New Berry Bucket Pin Upgrade

Part Number: 160697

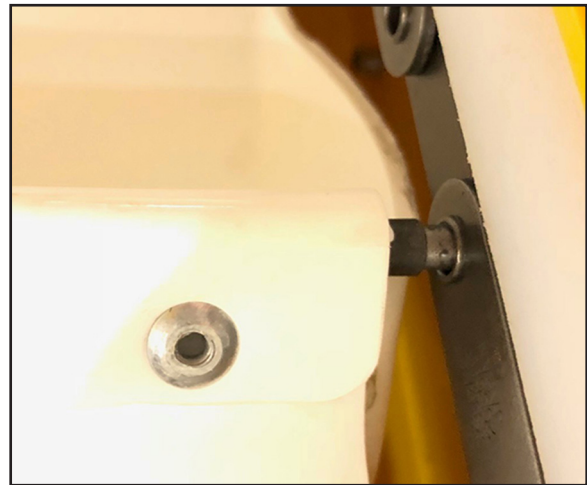
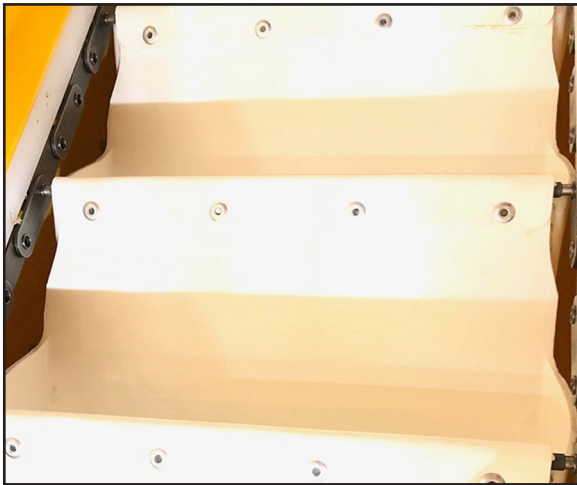
Oxbo now offers a new, improved bucket pin that is compatible with any 7440, 7420 or 9120 harvester. The new pin has the same diameter as the existing pins at either end, but is thicker in the middle to create a shoulder. This design delivers improved chain tracking and service life of the pin.

Note: the shoulder on the new pin is larger than the diameter of the hole in the chain and can not be inserted from the end. Therefore, the original pin is still valuable for quick, in-field repair during harvest.
